City of Santa Fe, New Mexico

memo

DATE: May 26, 2026
TO: Historic Districts Review Board Members
FROM: Heather Lamboy, Planning & Land Use Department Director #LL

2026-012126-HDRB. 515 Paseo de Peralta. Downtown & Eastside Historic District, Significant, Rebecca Wood, agent for George and Tina Feghali, owner, proposes to construct a 3,470 sq. ft. addition to a height of 24'-0" where the maximum allowable is 23'-0". Exceptions are requested to 14-4.6(E)(2)(III)(a) to exceed the maximum allowable height. 14-4.6 (E)(4)(II) for removal of historic materials, 14-4.6(E)(2)(II)(a) for constructing an addition on a primary façade and 14-4.6(E)(2)(II)(c) for an addition exceeding 50% of the historic footprint.

Figure 2. Excerpt from North Elevation (2/A203h)
 Scope of proposed addition shown relative to previously disturbed (noncontributing) façade. The proposed connection is primarily located at these locations; the exception concerns the 17" portion shown in red (38" at roof overhang).

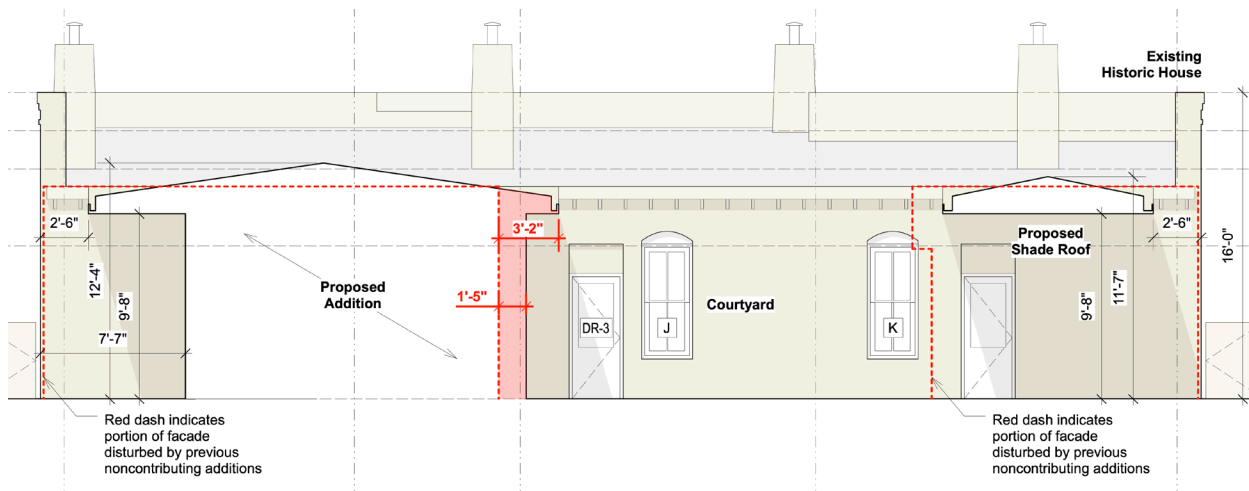
- *Response:* The proposed addition the North facade of the historic house will not damage the character of the district, as its massing will be separated from the historic house and the connections to the original structure will be primarily limited to portions of the facade already altered by previous noncontributing additions. The Board approved these additions for demolition in October 2025, and their removal will leave exposed interior walls that will need to be replaced. The proposed design lightly touches the original house at two locations on the east and west ends of the façade, and this exception only concerns a 17” wide portion of the North façade (3’-2” wide at roof overhang) where the new structure touches the historic house outside previously disturbed areas (see Figure 2).

- The primary mass of the proposed addition will be set back 12 feet from the historic house, preserving the legibility of old from new. At the East end of the facade, an interior space about 18 feet wide will provide the primary “bridge” between the original house and the addition, and it will attach at portion of the north façade left exposed after demolition of a noncontributing addition. The interior space is recessed beneath a roof overhang on both sides. Its roofline is set back 2’-6” from the corner of the original North façade, and its interior mass is set back 7’-7” from the corner to further differentiate the addition and preserve the legibility of the original massing and historic brick parapet at the Northeast corner. This shift pushes the addition Westward and slightly outside the previously disturbed façade area, creating the overlay described in this exception. This alignment also allows the new construction to continue the line of one of the primary original structural brick walls within the historic house and to extend the space of a historic hallway. The existing wall below the roof overhang will be preserved, and no existing historic doors or windows will be compromised or altered in any way. Newly exposed exterior wall will be finished to match the adjacent historic stucco.

- A new roof structure at the West will create covered outdoor space and is similarly set back about 2’-6” feet from the historic Northwest corner. This roof measures about eleven feet wide and will only touch the previously disturbed portion of the North façade – no exception for this work is required. Newly exposed exterior wall below and above the roof will be finished to match the adjacent historic stucco. An existing opening through the historic brick wall, currently an interior hallway, will be fitted with an exterior door matching the other historic door centrally located on the North facade. A historic photo from around 1915 shows exterior door (**Exhibit B**), and the design proposes returning to this original function.

Staff Response: Staff finds that this criterion is met. The massing of the building and the setbacks will allow for the addition not to dominate the significant primary structure.
